WCAP-14572  
Revision 1-NP-A  
Supplement 1

## **Westinghouse Structural Reliability and Risk Assessment (SRRA) Model for Piping Risk Informed Inservice Inspection**

SUBJECT: SAFETY EVALUATION OF TOPICAL REPORT WCAP-14572, REVISION 1,  
"WESTINGHOUSE OWNERS GROUP APPLICATION OF RISK-INFORMED  
METHODS TO PIPING INSERVICE INSPECTION TOPICAL REPORT"

**Figure - 1 Uncertainty Bounds Related to Values of Calculated Failure Probabilities**

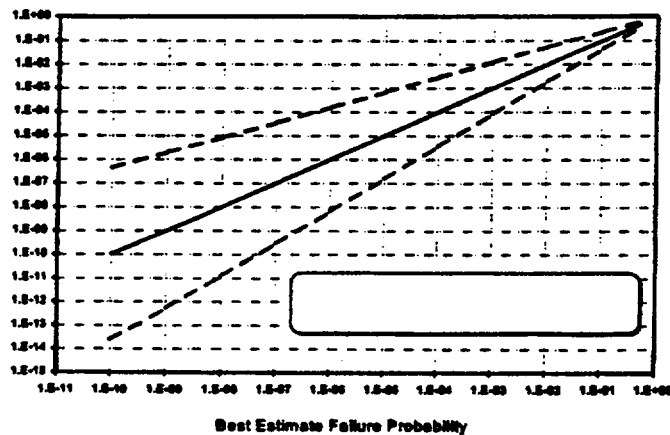
As part of the staff's review of the WCAP methodology, independent audit analyses were performed by PNNL to estimate the uncertainties in the calculated failure probability for a piping segment. Highlights of the uncertainty studies are documented in NUREG-1661 (Ref. 15). The results from the uncertainty studies are illustrated in Figure-1 and summarized below:

4. The calculations for components with very low failure probabilities are particularly sensitive to the tails of the distributions assumed for input parameters such as flaw depths and crack growth rates. The large uncertainties in the calculated failure probabilities are a direct results of the fact that the tails of these input distributions are based on extrapolations from actual data.
5. Failure rates for components with high calculated failure probabilities can be assessed for consistency with plant operating experience and with industry data bases on reported field failures. The ability to make such comparisons helps to minimize the uncertainties in the calculated probabilities.

To ensure that the potential impact of uncertainties is adequately addressed in the categorization of piping segments, Westinghouse committed to add the following as part of a future revision to WCAP-14572 [item 19, Ref. 8]:

"In addition to the sensitivity studies described above, a simplified uncertainty analysis is performed to ensure that no low safety significant segments could move into the high safety significance category when reasonable variations in the pipe failure and conditional CDF/LERF probabilities are considered. The results of the evaluation along with other insights are provided to the plant expert panel."

**Figure 4-2 Comparison of SRRA Model With Flow Assisted Corrosion Data**

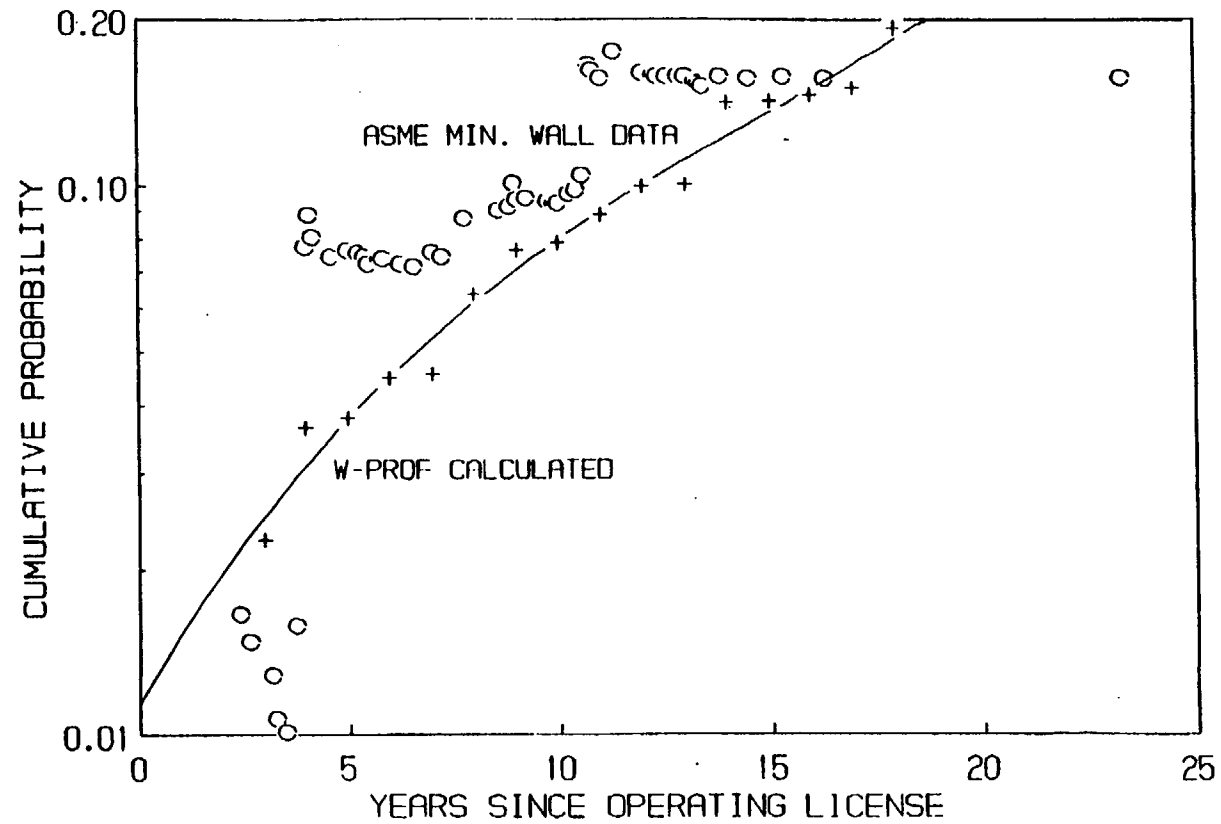
Figure 4-2 of WCAP-14572, Revision 1, Supplement 1, graphically compares SRRA model predictions with industry plant data relative to the probability of violating minimum wall thickness criteria because of flow-accelerated corrosion wastage. The staff had expressed a concern (Ref. 9) that the graph indicates that the SRRA model tends to over-predict the failure probability early in plant life and to under predict later in life. In the public meeting on September 22, 1998 [item 7 (a), Ref. 8], Westinghouse explained that the minor over-prediction early in life is attributable to lower plant startup capacity factors (fraction of time at full power and flow), while the minor under-prediction later in life is attributable to higher capacity factors during this more mature period of plant operation. The staff finds this response acceptable since the industry observed failure rates due to wastage are within a factor of 2 to 3 of the SRRA calculated values even though the calculation was based upon data averaged values of pipe size and wall thickness.
